MANAGER'S REPORT NO.
 83

COUNCIL MEETING
 1979
 12
 10

BE: BOUNDARY ROAD WIDENING - BANTING PLACE
DELEGATIONS: MESSRS. T. B. BARNES AND PETER SCHWIZGEBEL
WHO APPEARED BEFORE COUNCIL ON 1979 NOVEMBER 26

SUBJECT: BOUNDARY ROAD WIDENING - BANTING PLACE DELEGATIONS - COUNCIL MEETING 79 11 26

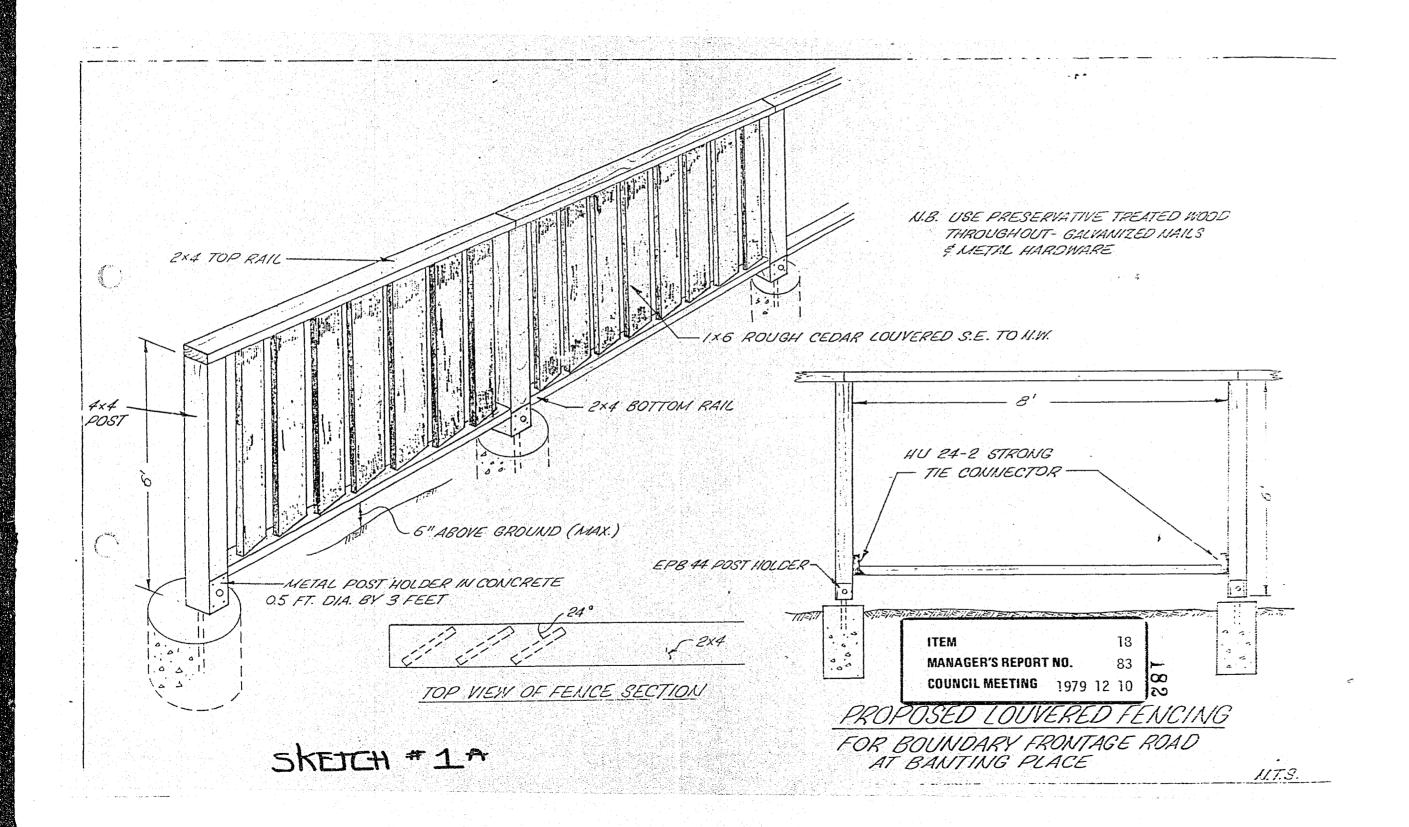
3. In response to this question we have attached Sketch #2 which shows the top of a maximum height truck (13' 6") located on the far side of Boundary Road and the sight line from it over the proposed six foot fence to the house at 3704 Banting Place. As exhaust stacks are all lower than 13' 6" maximum height for the truck unit, the attached Sketch #2 gives a benefit of doubt to the stack height. We should also add that for the purpose of estimating traffic noise impact such a straight line analysis has no applicability and in any case, the exhaust stack height of a vehicle is not the most relevant factor in estimating the overall effect of traffic noise. It should be noted that trucks in the most easterly lane are completely out of sight of 3704 Banting Place.

- 2. It was requested that the warrants for the proposed traffic signal at Marine Drive and the Banting Place access road be defined.
- 3. It was also requested that your report contain a line diagram to show the twelve-foot maximum height of the exhaust stacks on diesel vehicles and how they will affect the homes on Banting Place taking into account the height of the fence.
